Commentary on the Risk Analysis for the Proposed Emera Brunswick Pipeline Through Saint John, NB

By
Richard B. Kuprewicz
President, Accufacts Inc.
kuprewicz@comcast.net
October 18, 2006

Figure 1: Bercha QRA Mass Release Over Time for Rupture within City Segment

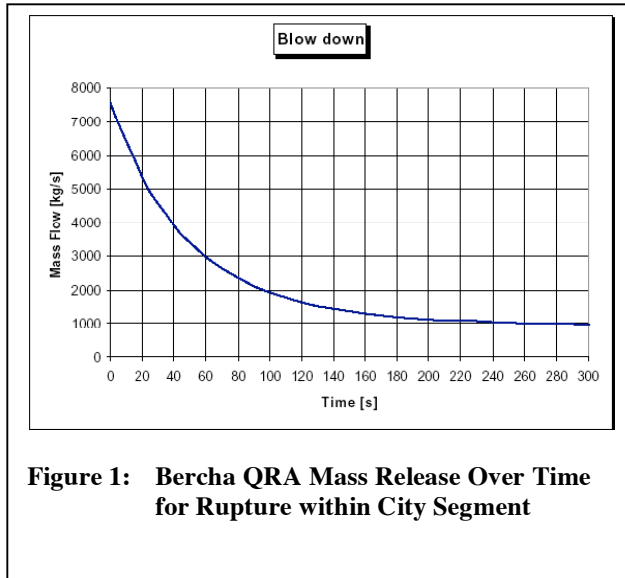
author's experience, the release curve depicted in the pipeline Application/Bercha QRA is not indicative of a conventional 30-inch pipeline, but is a fingerprint more characteristic of a rupture associated with a larger diameter conventional steel pipeline (e.g., 36 to 42 inch). The Applicant/Bercha QRA's analysis is moot on several specific critical inputs utilized to develop their rupture mass release over time curve. Even taking into account various system transients, the mass release is not what we would expect of a conventional 30-inch steel pipeline. The reduced friction factor associated with FBE coating on the inside of the steel pipe may play a role in the Applicant's increased mass release curve.

It is the Applicant's responsibility to clearly explain and defend their worse case rupture mass release curve, that is so important in evaluating potential impact zones.

2. Further detail from the pipeline Applicant is warranted to support understanding of the rupture mass release over time curve for the pipeline segments within the city of Saint John. The specific pipeline capacity throughput that defines this curve should be clearly stated.

Figure 3: Example of a Heat Flux versus Distance Plot - Gas Pipeline Rupture Jet Fire

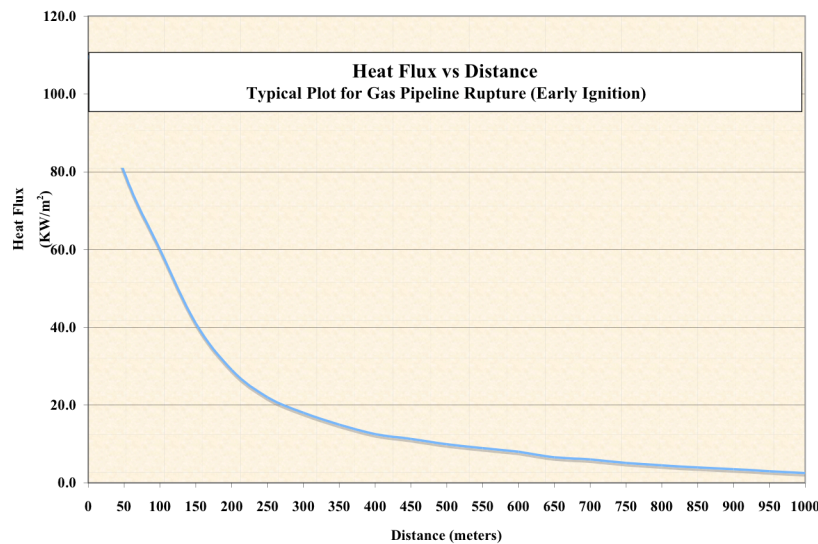
To properly evaluate the proposed pipeline route through the city of Saint John, the pipeline Applicant needs to develop and provide an early ignition pipeline rupture heat flux versus distance curve similar in format to that depicted in Figure 3 that can be publicly reviewed and defended.

If one were to determine that 10 KW/m² was a reasonable upper limit to define a potential impact area, Figure 3 would suggest a potential impact radius of 500 meters, a number well beyond 300 meters. The pipeline's Application/Bercha

QRA's own studies indicate 20 KW/m² distances well beyond 500 meters.¹⁵ This underscores our previous observation that it is the pipeline Applicant's responsibility to develop and defend a heat flux versus distance plot capturing early ignition that is so important to large diameter high-pressure pipeline routing considerations.

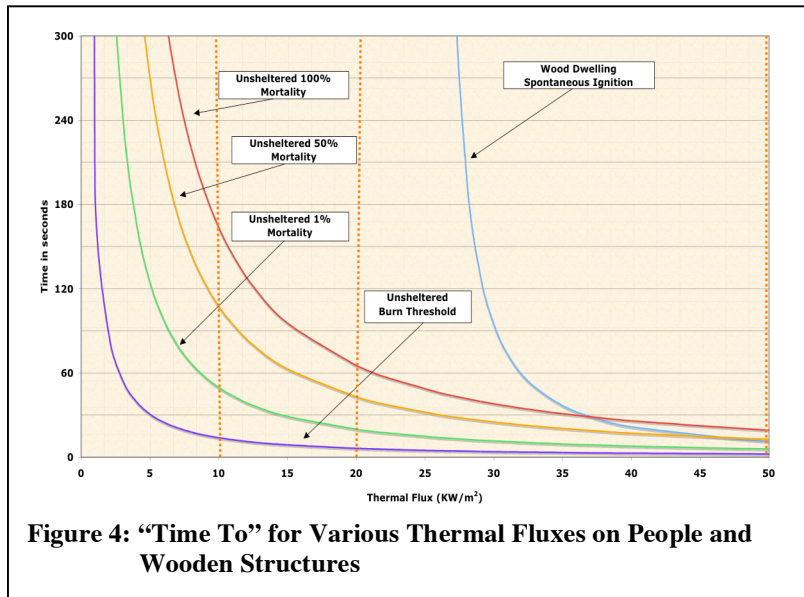
From these series of curves it is readily evident that high heat flux and unsheltered survivability is measured in seconds. Figure 3 and 4 curves also indicate that the 300-meter hot zone boundary limit suggested in the Fire Department Risk Analysis report is not large enough for an urban setting, and that much of the warm zone is also inappropriate for a new pipeline established in a sensitive receptor area in

300 meters is not an appropriate safety zone for this pipeline if ruptured, given the high heat flux potential/low survivability associated with rupture failure.

As can be seen from Figure 4, it is the heat flux ranges between 10 and 20 KW/m² that raise the most uncertainty about survivability that can drive proper sizing of large potential impact zones in highly sensitive areas. In our previous report on this pipeline, we cautioned the foolishness of taking credit that panicked individuals will run away from the high heat flux fire.¹⁴ Those who make such statements have, in all probability, never been in a hydrocarbon fed high heat flux event. Unfortunately, none of the figures in this report should be taken as an absolute certainty given the wide variation of factors that can introduce considerable doubt during an emergency. It is the pipeline Applicant's responsibility to provide and defend these determinations using the processes defined in this paper. Prudence would counsel that one err on the side of caution which leads to a lower heat flux limit and larger potential impact zone in sensitive areas such as cities. Assuming that rupture failure will never occur is most unwise, if not reckless.
